For: Truro Cycle Campaign

Design review - cycling & walking crossing, A30/A390 Chiverton Cross junction

By: Transport Initiatives LLP

May 2022

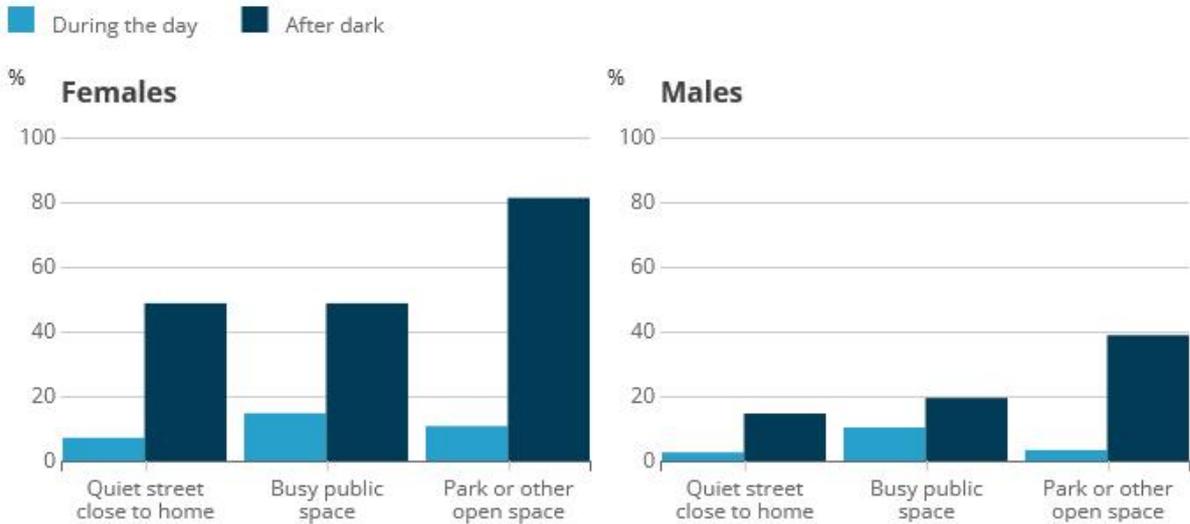
The Chiverton Cross underpass will be nearly 74m long, with internal dimensions of 4.0m width and 3.5m height, with usable headroom of 2.7m allowing for internal structures. It will be lit.

LTN1/20 suggests that where the two-way flow of cyclists in any peak hour is less than 300, a 3.0m wide unsegregated shared use path is acceptable. If the path is bounded by a high vertical wall (as is the case in an underpass) then the path should be 500mm wider on each side.

The recommended height of the underpass is determined by its length. LTN1/20 states that 2.4m is the desirable minimum for underpasses up to 23m in length and 2.7m beyond that. This is due to a requirement to admit more natural light. If a 2.4m high ceiling allows insufficient light into a 23m long underpass then the equivalent length for a 2.7m high ceiling is 26m, clearly much shorter than the 74m of the underpass here.

While there are cyclepaths through disused railway tunnels considerably longer than 74m, the cross section of the tunnels themselves is far larger. We consider therefore that a 74m underpass only 2.7m high will feel extremely claustrophobic both by day and by night.

DMRB CD195 paragraph E/4.37. states *“Kerb separation shall be provided between cycle tracks and any adjacent pedestrian facilities.”* This conflicts with LTN1/20 which assumes that cyclists and pedestrians can mix at low flows. However, if LTN1/20 is used to find the minimum widths the underpass width would need to be 5.7m to cover the minimum widths of the cycle and pedestrian sections plus adjustments for the kerb on one side of the cycle track and the vertical wall on the other. The underpass is thus substandard based on the requirements in CD195.
